FORM 5 SUBMISSION ON PROPOSED QUEENSTOWN LAKES DISTRICT PLAN (STAGE THREE) UNDER CLAUSE 6 OF THE FIRST SCHEDULE, RESOURCE MANAGEMENT ACT 1991

Name of Submitter: Aurora Energy Limited

Dated 18 November 2019

Planning maps within a 20 metre vicinity of 39 Ballantyne Road shown below

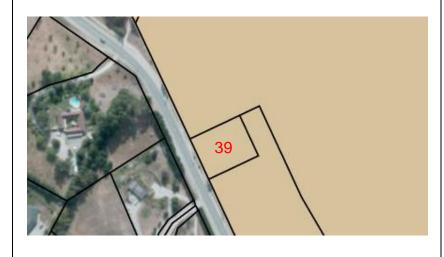
Area is zoned Low Density Suburban Residential Zone

Oppose

An existing zone substation is located at 39 Ballantyne Road (Ballantyne Road Zone Substation (BRZS)). The BRZS is subject to designation decision 337 as part of PDP Stage 1 so the particular zoning of that site is inconsequential to the types of activities that can occur.

Aurora is concerned about the potential reverse sensitivity effects on the BRZS arising from residential dwellings being built in close proximity to the BRZS. The provisions of the Low Density Residential Suburban Zone enable a density of at least 450m^2 which could lead to significant reverse sensitivity effects on Aurora's BRZS.

Remove the notified zoning;

OR insert a building restriction area over the Low Density Residential Suburban Sub-Zone in the area 20 metres from the cadastral boundary of 39 Ballantyne Road. A suggestion of where to place this boundary has been produced at Appendix B with a red outline.
